Project: **Proposed 38-Lot Woods at Viewcrest Plat**
352 Viewcrest Road, Bellingham, WA

Subject: **Geohazard Review Addendum – Stormwater Outfall Plan**

Figure 3

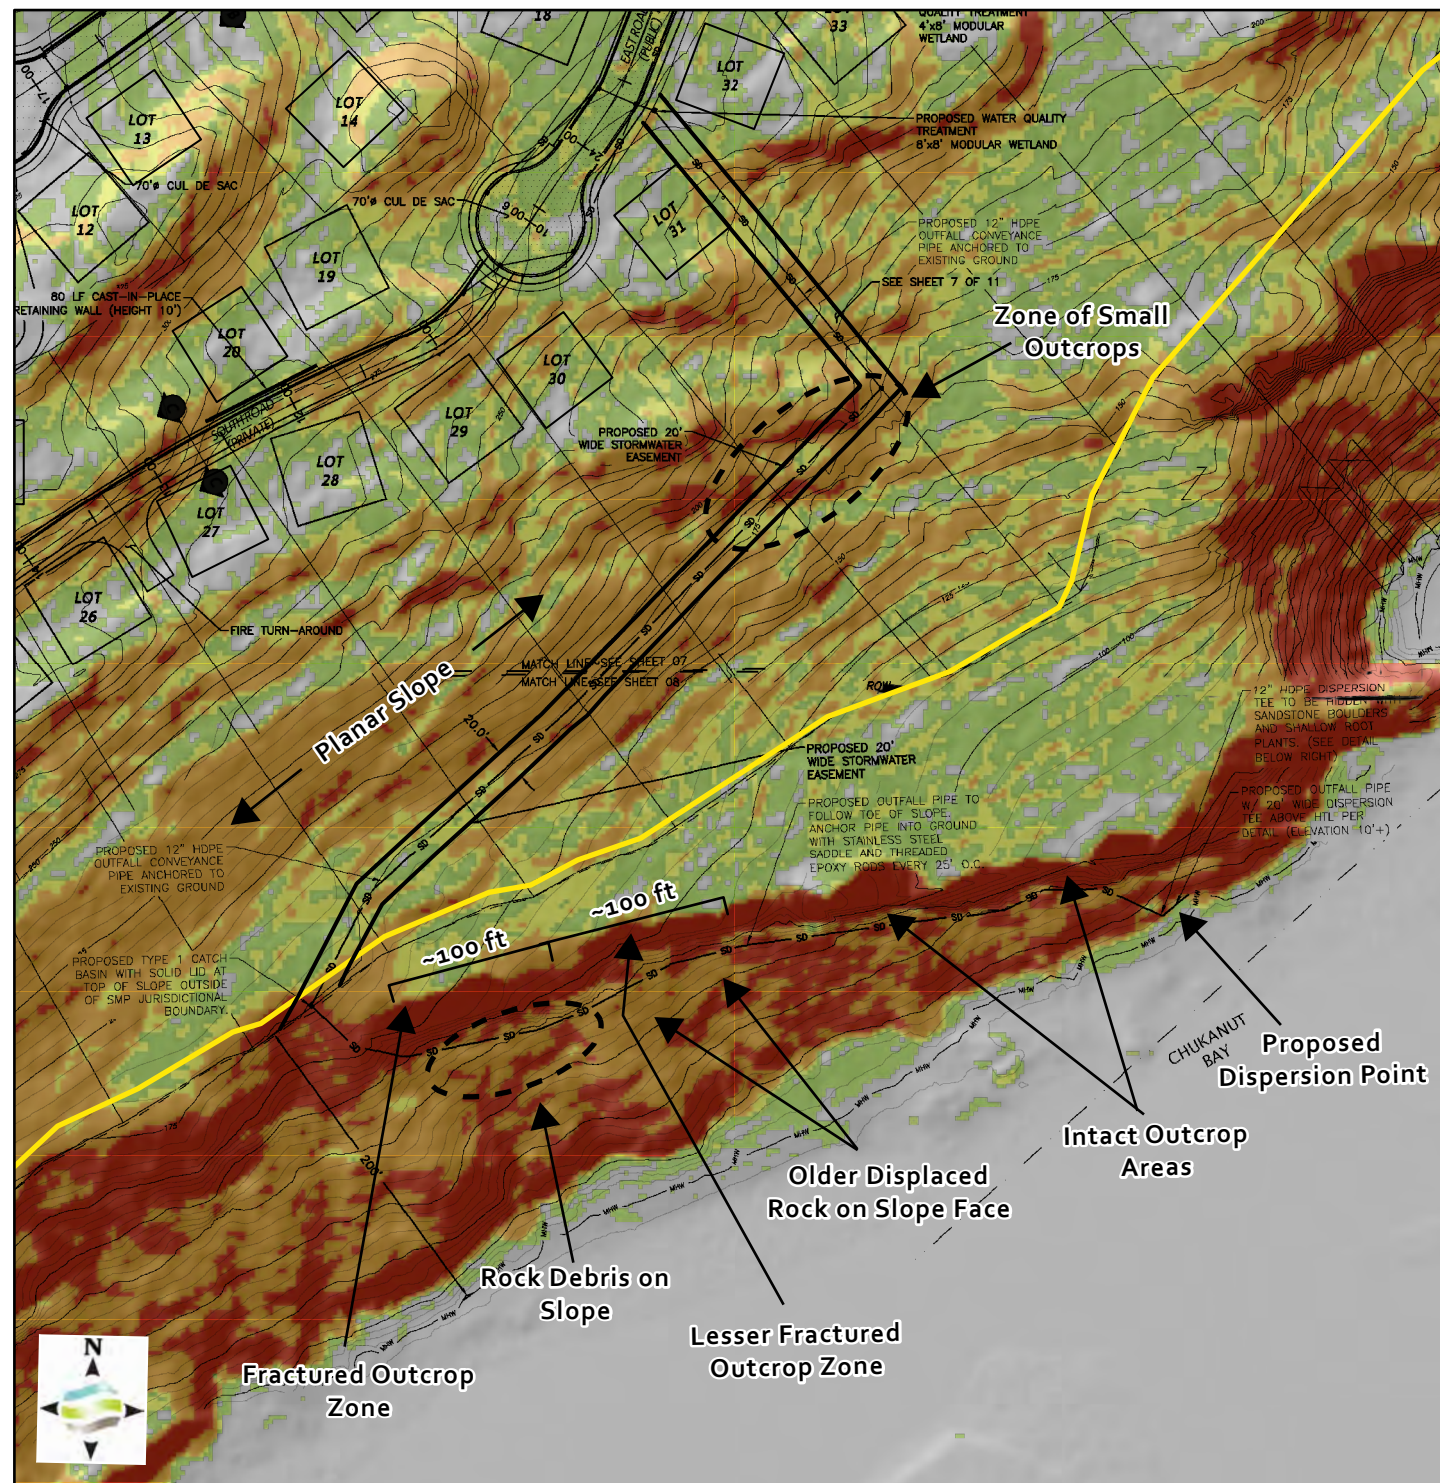
Weather conditions at the time of the visit were sunny and dry. Vegetation allowed for adequate access along the area of interest. A draft version of the attached Southern Region map (Figure 3) was produced overlaying outfall drawings on GIS slope-shade data to easily identify features in the field. The GIS map was loaded into a GPS-based application (Avenza) for continuous location tracking. As we traversed along the alignment, we observed surrounding slope stability conditions. We also assessed for potential

The lower slope extent of the tightline path includes a short top segment about 40' – 50' long from the top-of-bluff catch basin that is oriented downhill. This transitions into a main section around 500' long that traverses across the slope near the base of an exposed sandstone bedrock cliff. The last segment of about 50 feet length travels downhill to the location sited for dispersion on a large vegetated sandstone pad just above the Ordinary High Water Mark (OHWM) and High Tide Line (HTL). Refer to Figure 3 for illustration.

STORMWATER OUTFALL

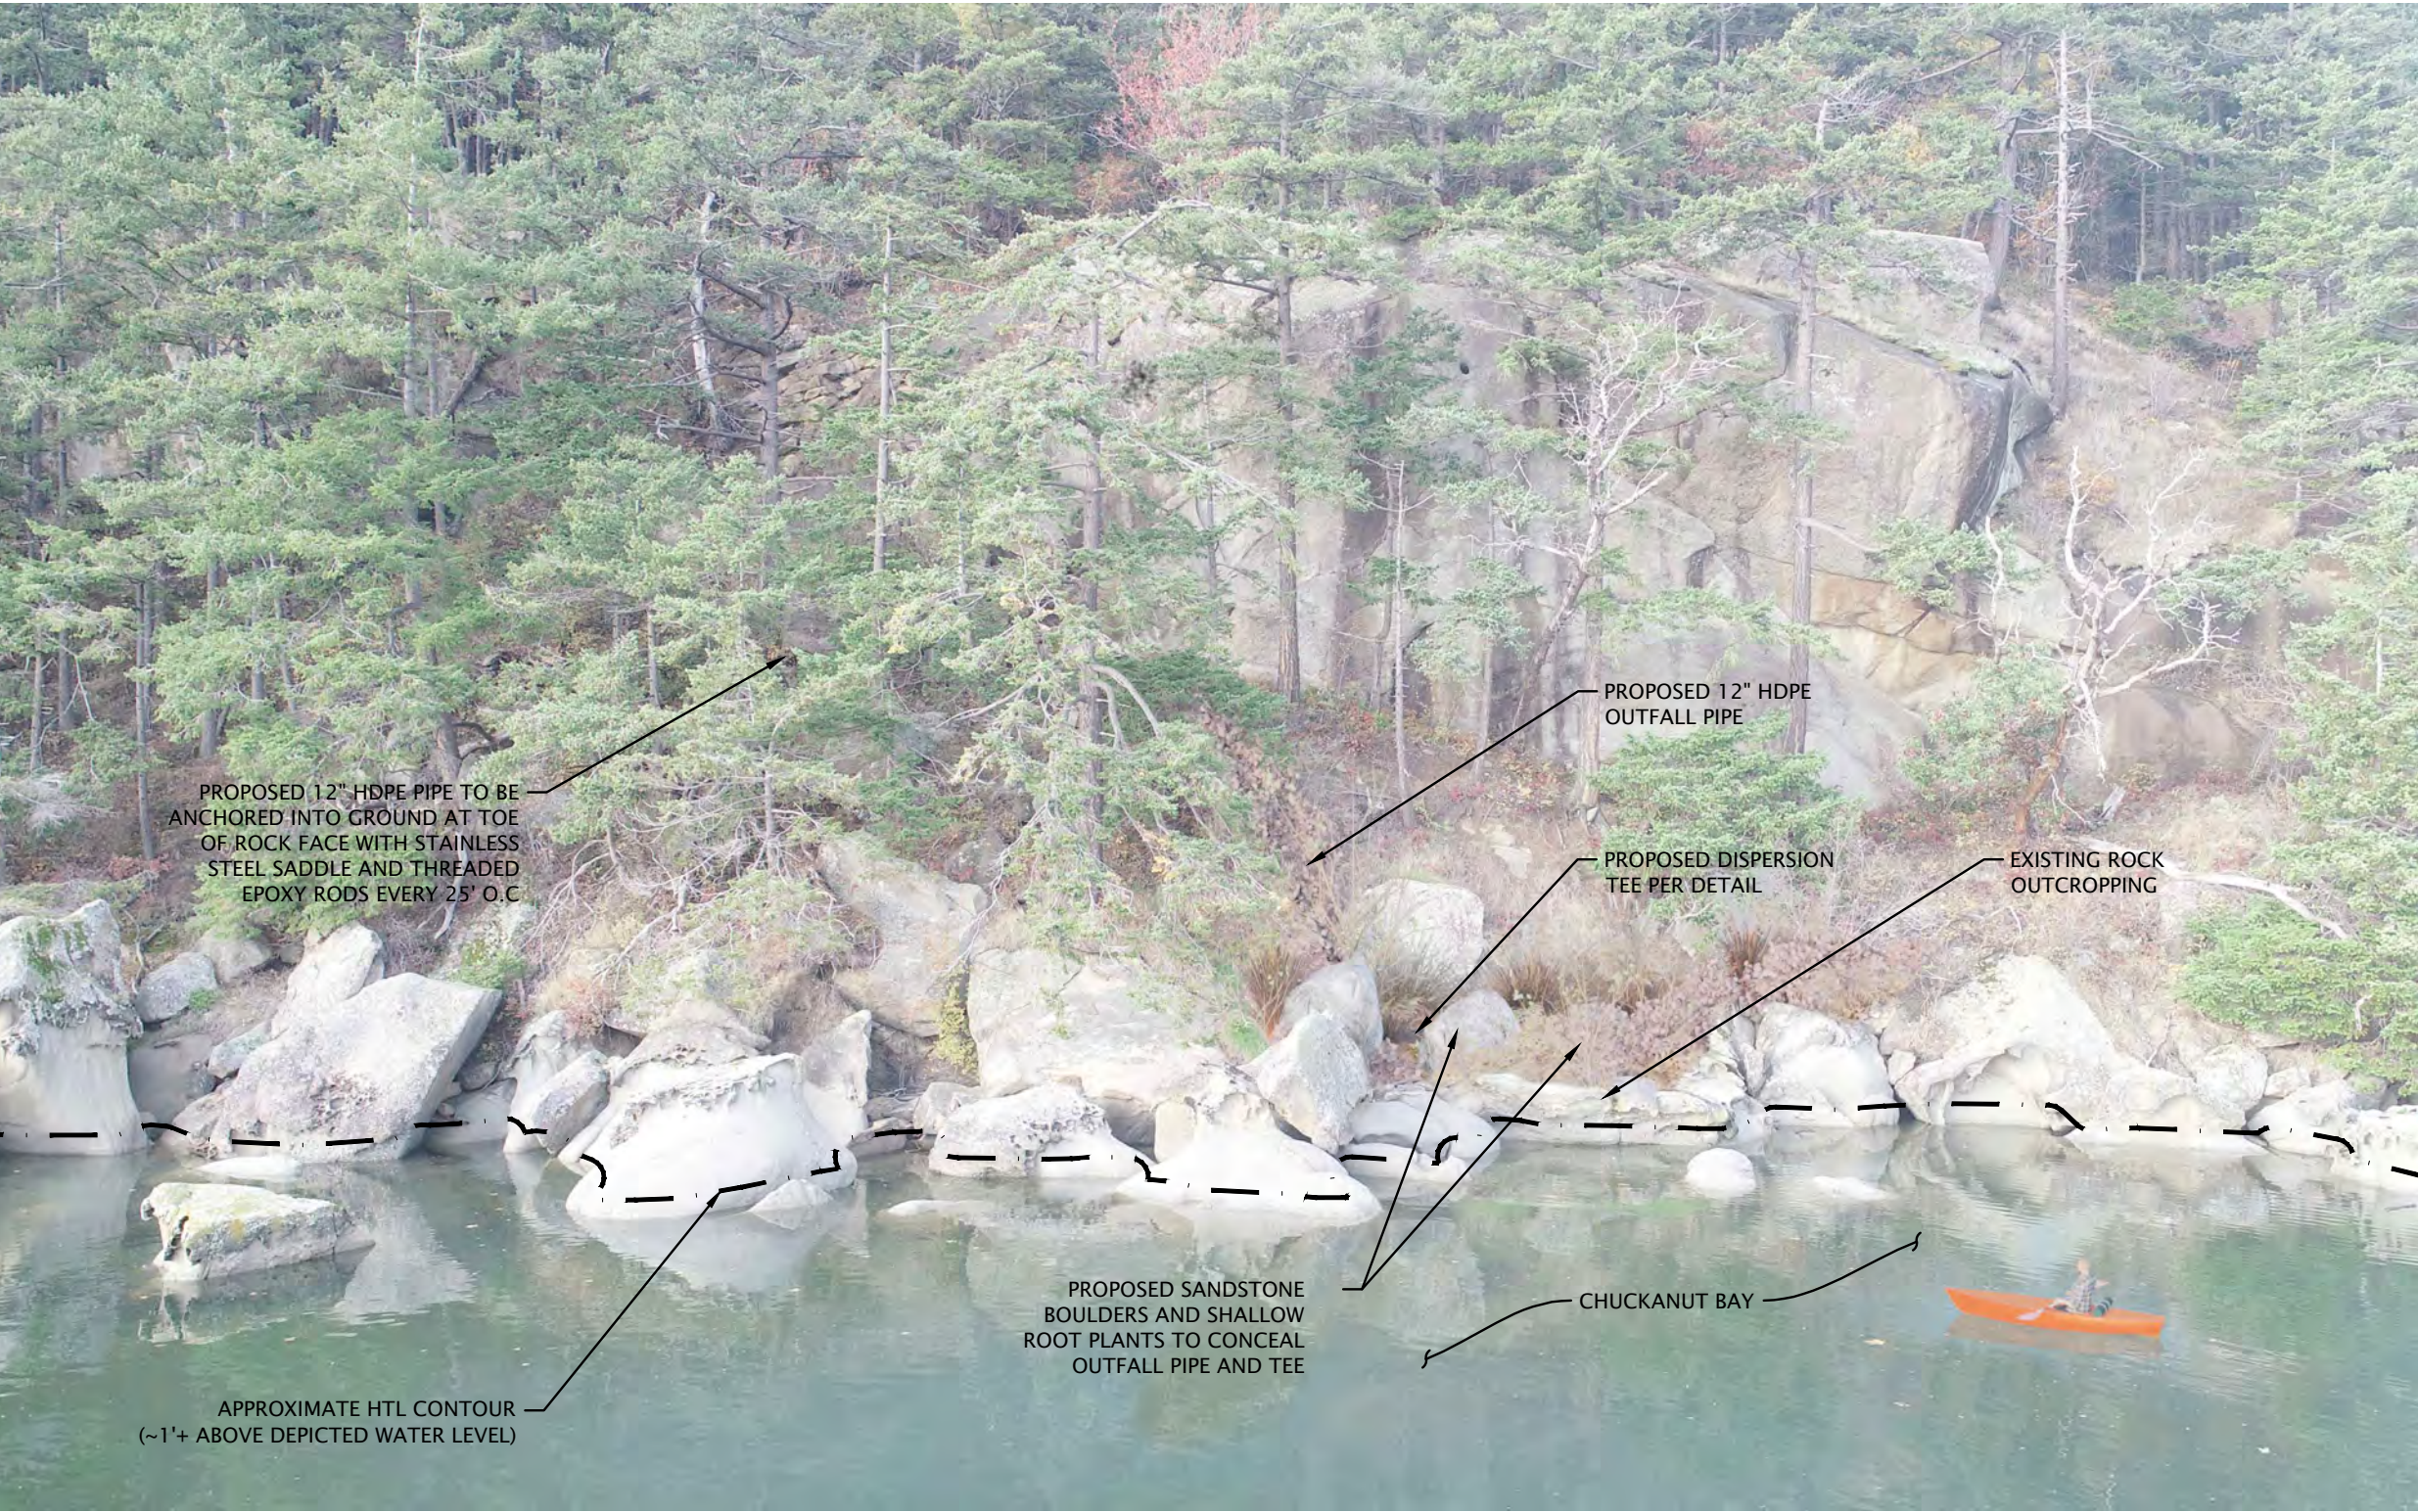
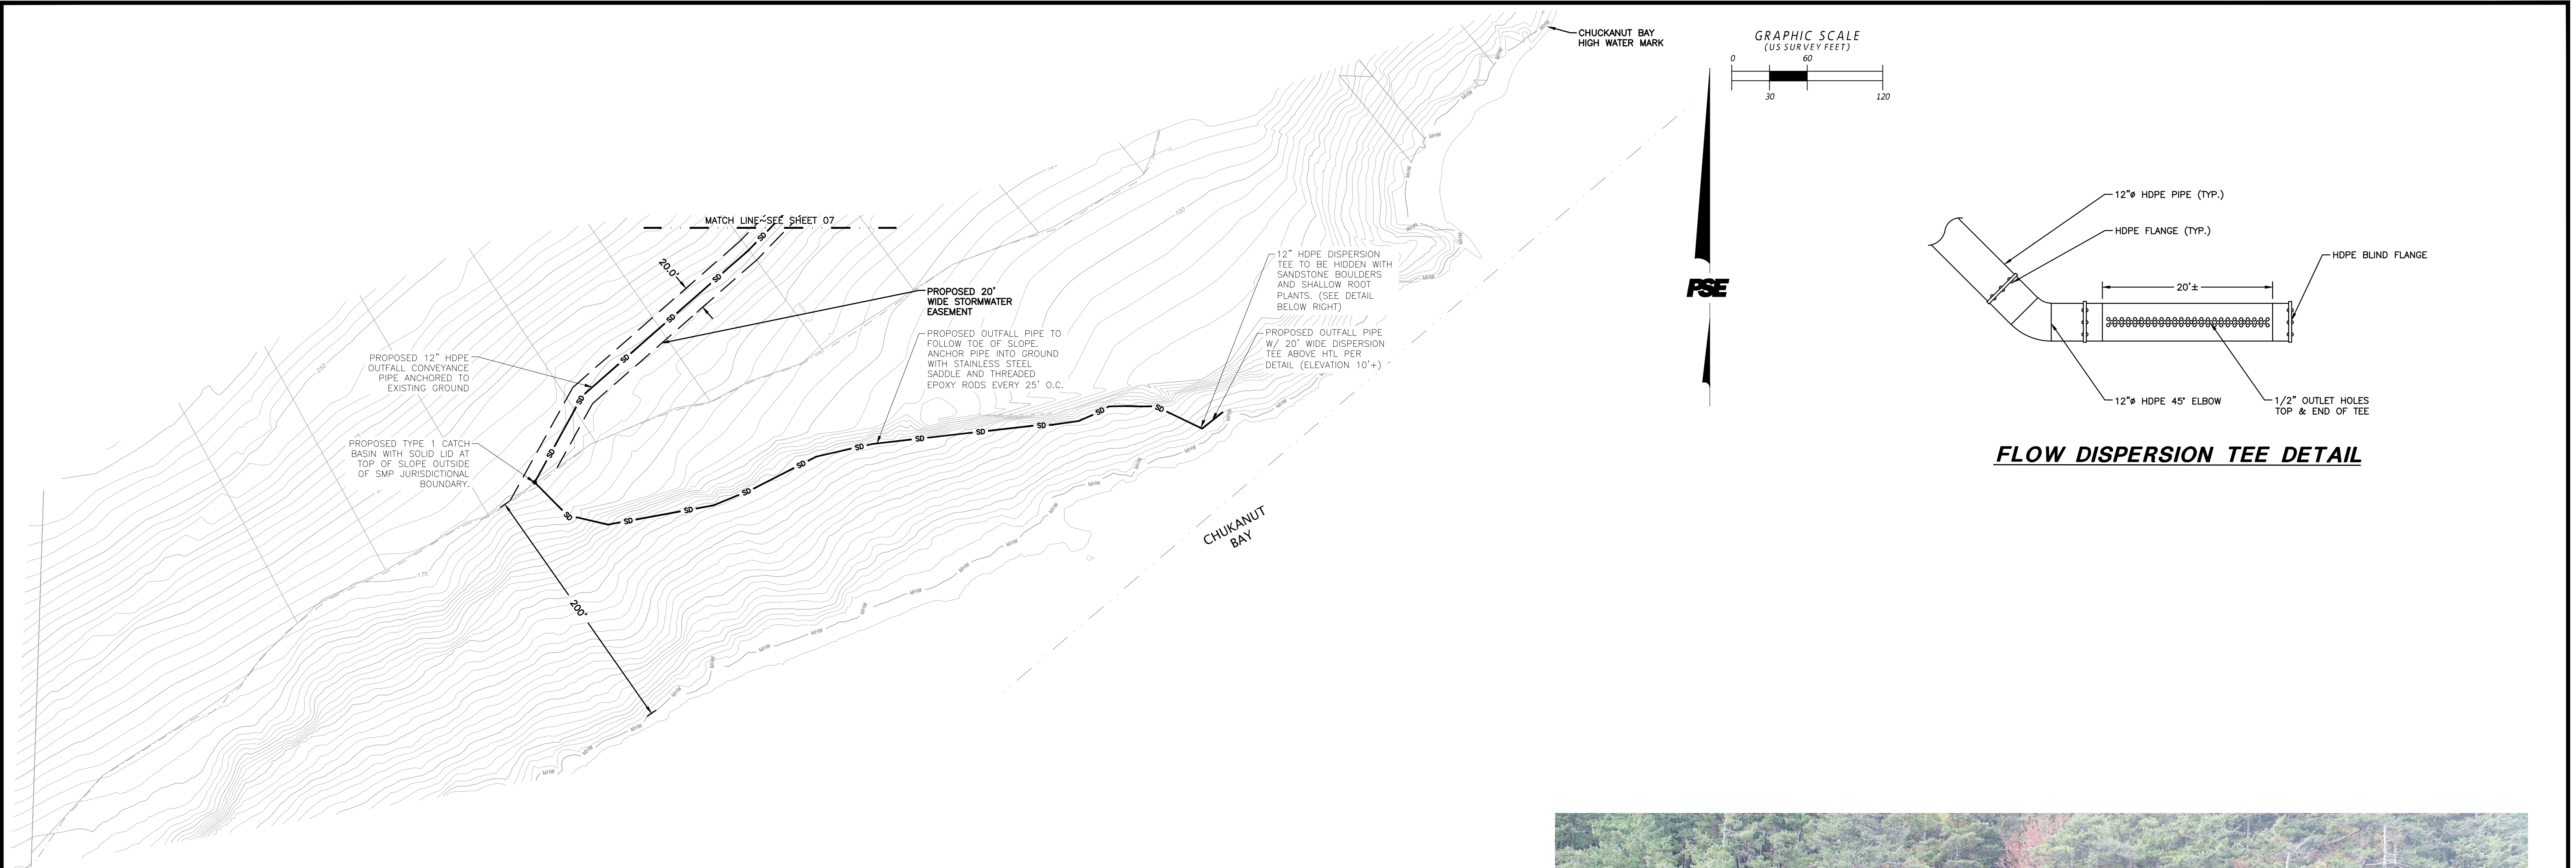
Two areas of greater-than-typical challenge for tightline installation have been identified which pose unique difficulties that must be addressed in final design and construction. The approximate locations and extents of these areas are noted on Figure 3. For the purposes of this review, we have assumed that the general routing concept as shown on the Preliminary Plat drawings will be pursued for final design.

Upland Slope Small Outcrop Zone: This zone may present difficulties for conveyance pipe construction and long-term outfall security due to the variability in topography as a function of the local rock outcrops. With careful planning and preparation of a suitable corridor the depicted route is expected to be viable, although pipe installation could incur greater-than-typical efforts and costs to do so.

Bluff Slope Rock Fall Zone: After descending onto the lower bluff slope, the conveyance piping is proposed near the base of the tall rock exposure. While the eastern majority of this rock face appears intact with a low rock fall risk, the western portion appears prone to occasional rock fall from fractured outcrops. In particular, the first approximately 100 feet along the cliff face displays an elevated risk of incidental rock fall. This is evidenced by common rock talus on the underlying slope which generally dissipates out from the outcrop. The next roughly 100 feet of slope also has common older rock debris but little evidence of recent activity.

- We encourage additional detailed reconnaissance and collaboration during final design to assess for routes for optimal avoidance of specific outcrop obstructions. For instance, an angled segment through Lots 30 and 31 may be considered as an alternative to the right-angle junction shown.

- One method to mitigate rock fall hazard from the cliff band is to adjust the alignment to traverse across the slope further away from the cliff exposure below elevated hazard areas. The hazard of rock fall directly impacting a downhill pipe generally lessens with distance from the source.

- A downslope shift on the order of 50 feet is interpreted to be sufficient to minimize rock fall impact risk, based on conditions observed during the recent reconnaissance. We recommend an alignment shift below the elevated hazard areas be considered for final design. Site conditions should be re-observed during final design to optimize the outfall path for rock fall protection.

- Constraints on pipe elevations appear to allow for such a downhill alignment adjustment while retaining suitable fall to reach the proposed terminus location. Our observation and map review of the conveyance zone also indicate there is adequate room along moderate slope areas to allow for an adjusted pipe alignment.

- Alternatively, or in tandem with a shift, the conveyance pipe should be constructed with additional shielding from rock fall impacts as needed for the final design location. Possible options include natural barriers (use of existing rock talus and large boulders for upslope shielding), or sleeving / covering the HDPE pipe with another material for impact protection where necessary (like concrete or steel casing).

- In addition to the above protective mitigations, shallow burial or inset of the pipe into natural topography will help minimize the potential for dislodged rolling or sliding rock debris to “catch” on the pipe as it travels downslope. We recommend the pipe placement be optimized to minimize a surface debris “catch” hazard by use of shallow embedment.
